<b>Cairngorms National Park Authority</b>
Planning Application No. 09/153/CP
<b>REPRESENTATION</b>
ACKNOWLEDGED 2/7/09

**Re: Planning application for erection of 30 houses and  
construction of access road at land south east of Millside  
House, Milton, Aviemore**

**RE: NO. 09/00109/FULBS Erection of 30 houses and construction of access road on land between Aviemore Burn and Aviemore Orbital Path opposite Grampian View, Aviemore.**

# Objection to Planning Application

# Overdeveloped - Evidence

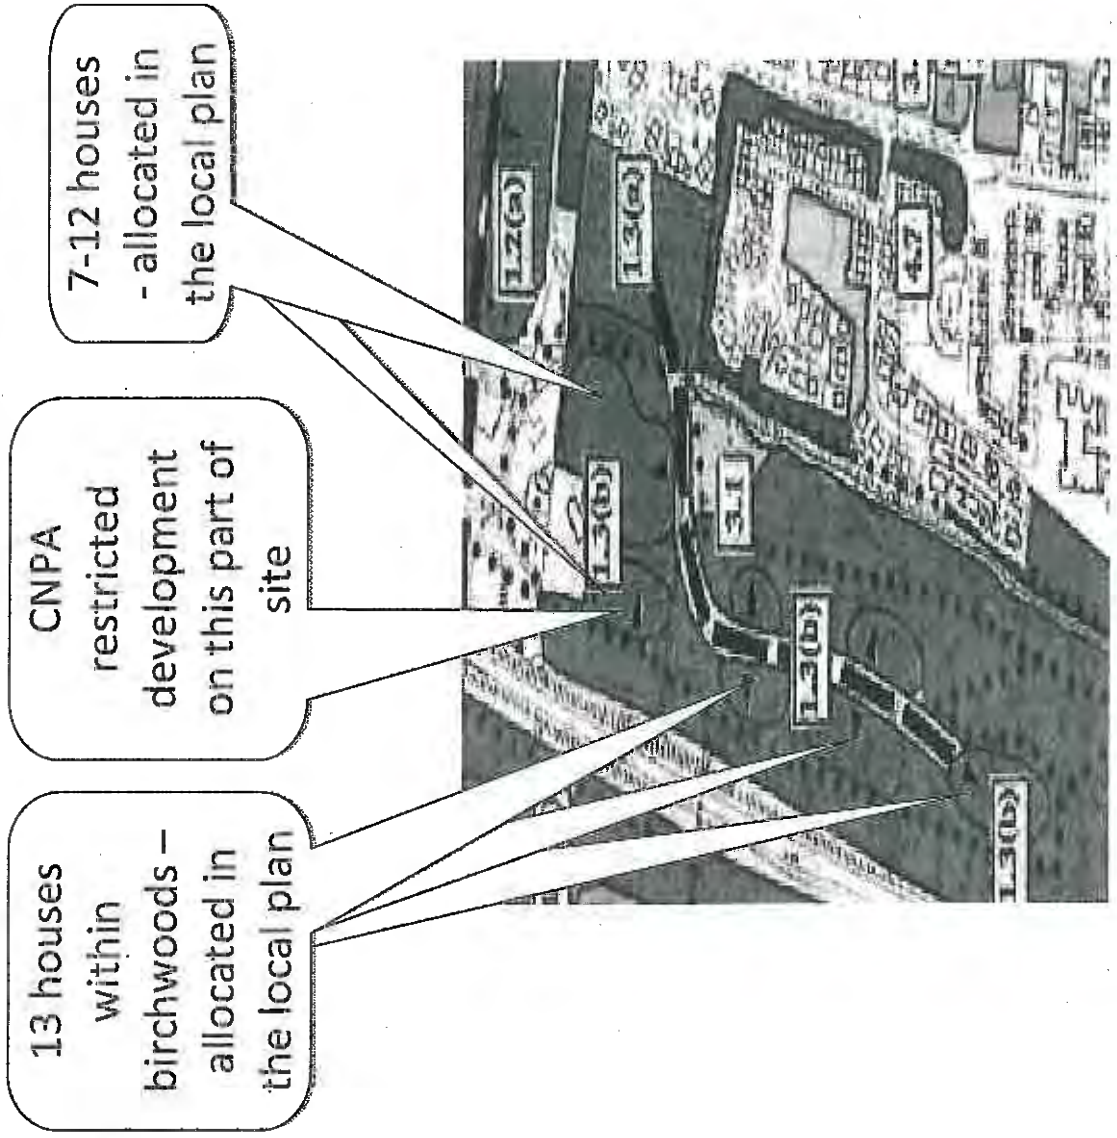
The local plan, referred to above, allocated 20-25 houses to be built in the combined areas labeled 1.3(b) (Map taken from the Local Plan 1997) 13 to be constructed within the birchwoods, otherwise known as Milton Woods, leaving 7 – 12 houses to be constructed on the site now being considered. Milton Woods has since been protected from development.

With the CNPA restriction on developing the western part of the site, as part of outline planning application 07/393/CP, the site allocation must therefore be further reduced.

## Overdeveloped - Evidence

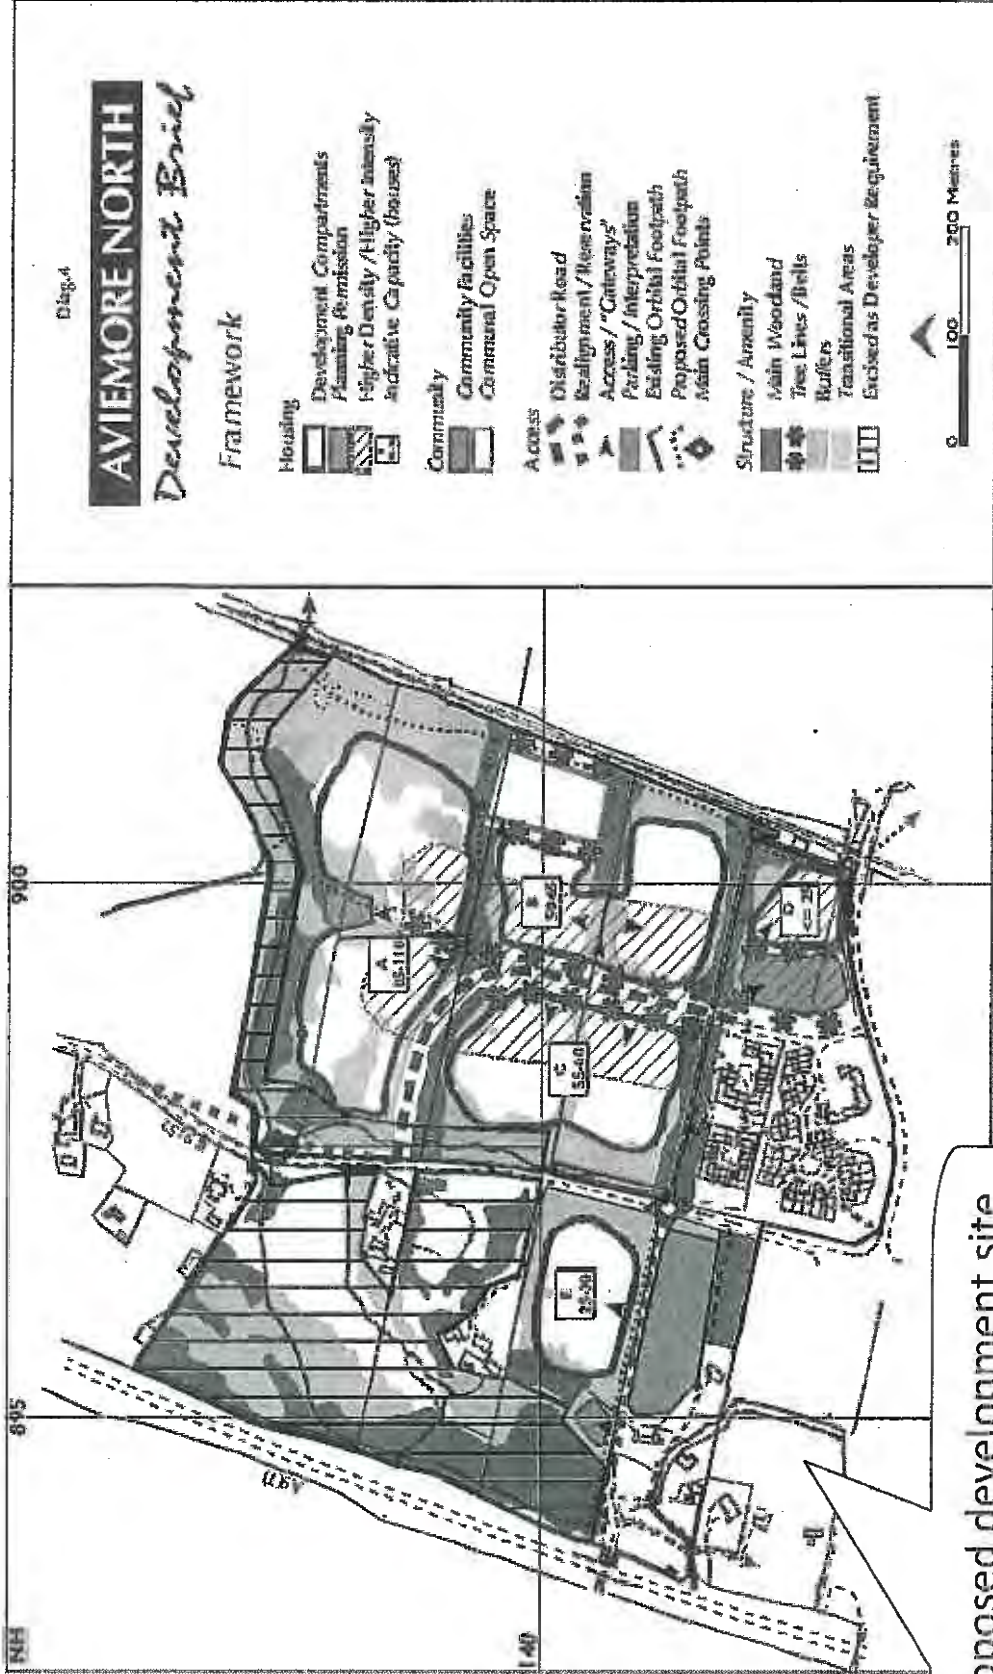
The applicants planning support statement makes reference to Highland Council's Aviemore North Development Brief 2000 for setting the layout of the more densely developed portion of this site.

Please refer to the map on the next page, taken from the Aviemore North Development Brief 2000 which clearly shows that this site is NOT part of the Aviemore North Development Brief 2000.

The high density remit is also situated within a more dense settlement as shown on the hatched area.

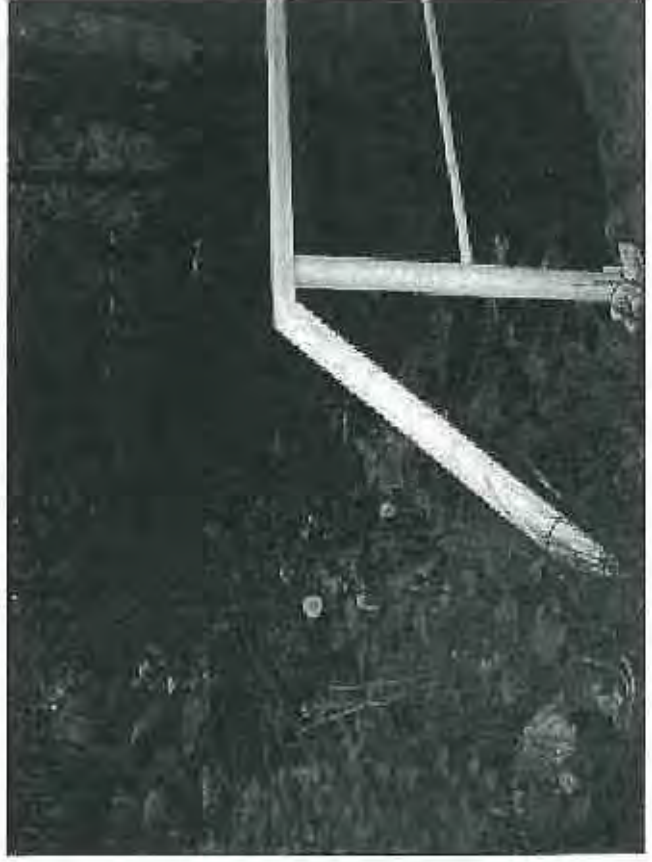
Significantly higher than in  
March 2008

- The following pages contain photographs taken on 8<sup>th</sup> March 2008 on the 3<sup>rd</sup> day of rain when the average daily rainfall recorded was:-  
Mon 6<sup>th</sup> – 1.4mm  
Tues 7<sup>th</sup> – 3.6mm  
Wed 8<sup>th</sup> – 6.8mm.
